RENESAS TECHNICAL UPDATE

Product Category	MPU&MCU	Document No.	TN-H8*-A391A/E	Rev.	1.00
Title	H8S/2112R Group: Modification regarding the Pin Assignments in the hardware manual		Information Category	Technical Notification	
Applicable Product	H8S/2112R Group	Lot No.	Reference Document	H8S/2112R Group Hardware Manual Rev. 1.00 (REJ09B0462-0100)	
		All lots

We would like to inform you of modification regarding the pin assignments in the H8S/2112R Group Hardware Manual.

Figure 1 Before changing

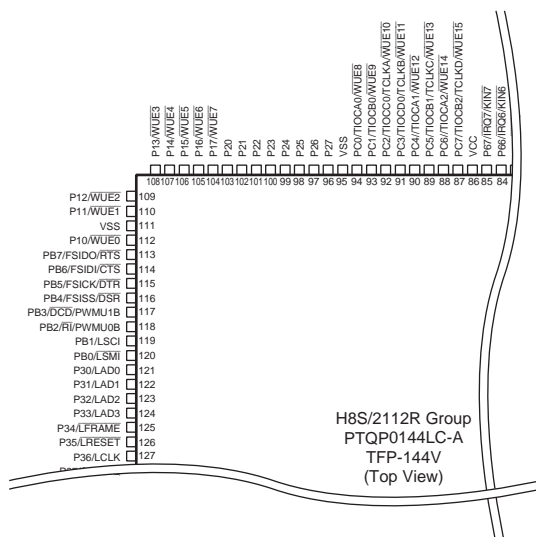
Item	Page	Revision
Figure 1.3 Pin Assignments (TFP-144V) 9 of 954		[Before change] Figure 1 of this document
		[After change] Figure 2 of this document
